PROJECT NAME: 20240312 BL072 – CHEMISTRY ADDITION – REPLACE AHU 1 THROUGH 4 – PHASE 1
OWNER NAME: INDIANA UNIVERSITY BOARD OF TRUSTEES
CES PROJECT NO. 2024-003.IUM
ADDENDUM NO. 2
DATED: 3/18/2025

This Addendum consists of four (4) Addendum page(s) and sixty-three (63) attachment pages totaling sixty-seven (67) pages. This Addendum shall supplement, amend, and become part of the Bid Documents. All Bids shall be based on these modifications. Bidders shall acknowledge the receipt of this addendum on their Bid Form.

ATTACHMENT A - SITE PHOTO / DUMPSTER LOCATION

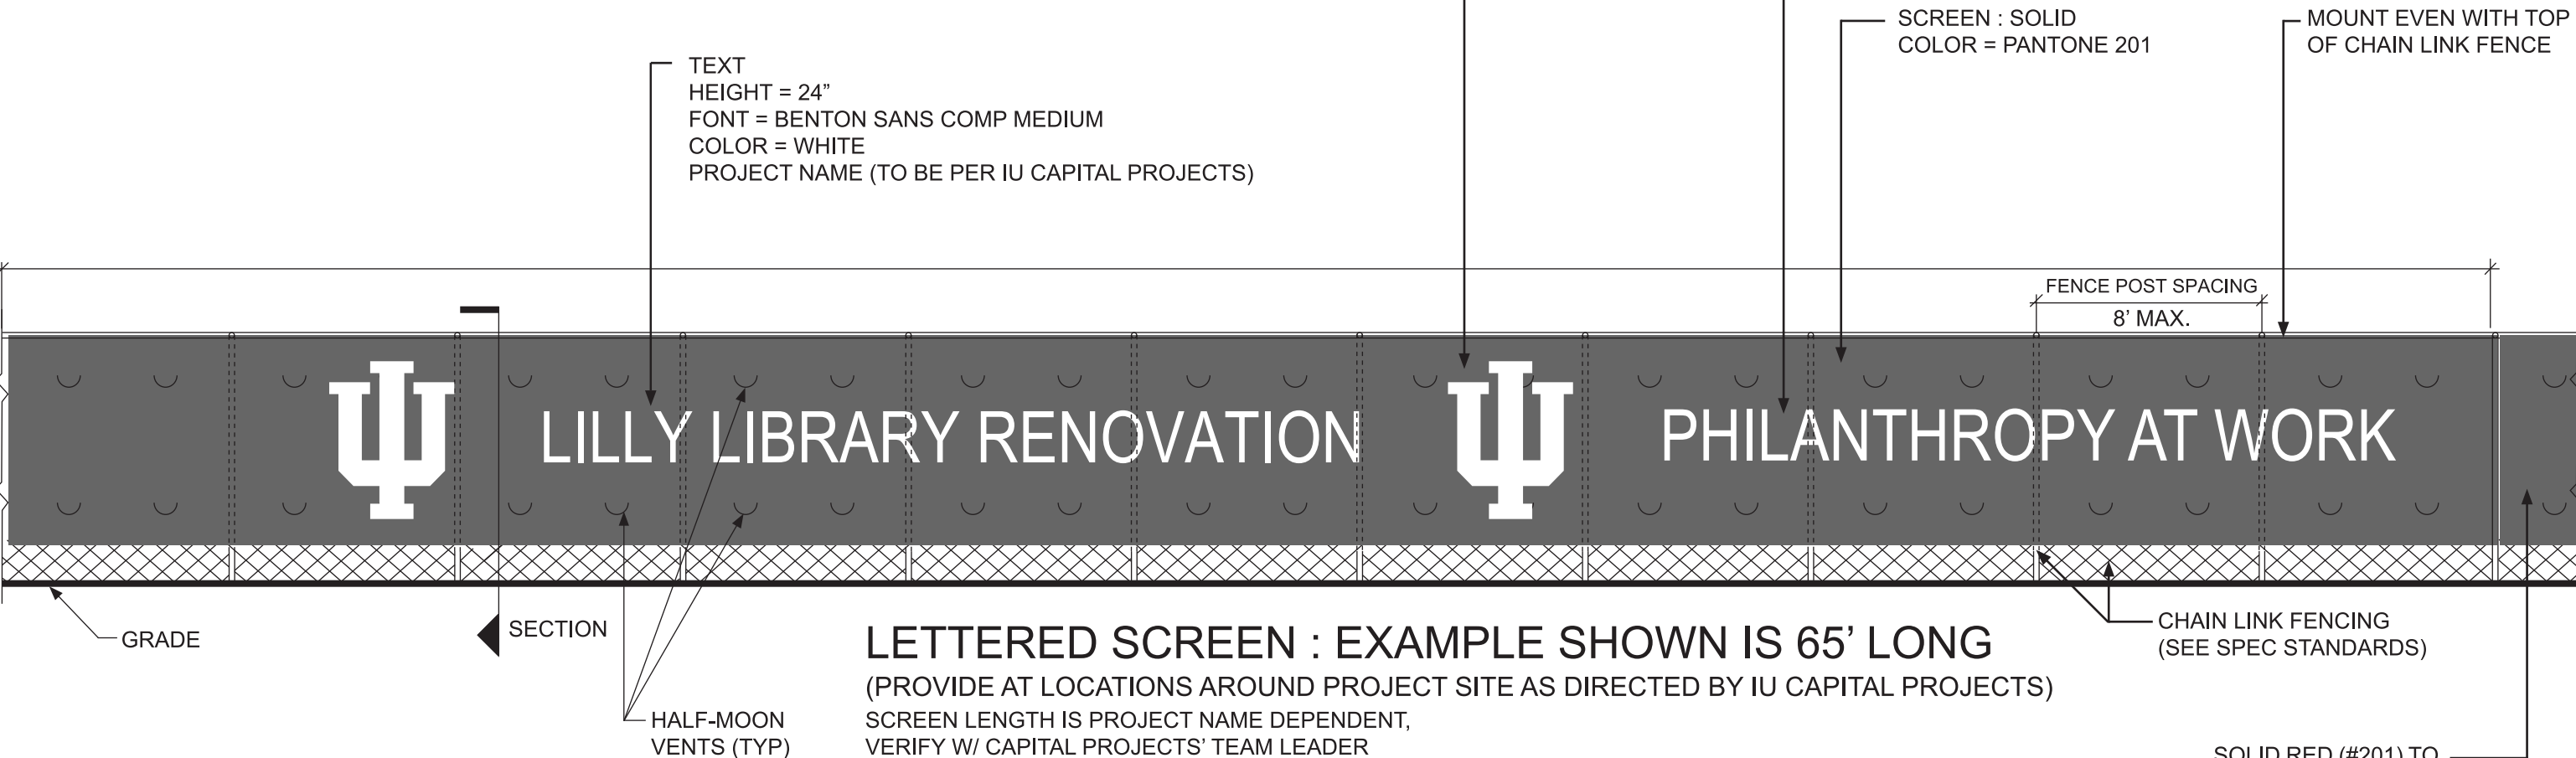
- 3.1** A dumpster will be permitted per the attached site plan (shown as a white rectangle) for the heavy demolition period, roughly from September 18 until December 31, 2025 – *Attachment A* (Site Photo) . Successful bidder will coordinate exact dumpster sizing and placement with Construction Manager and Building Manager. 6'FOOT temporary fence chain link fence and Pantone 201 privacy screen (per IU standard) - *Attachment B* - shall be provided around dumpster, and locked when not in use.
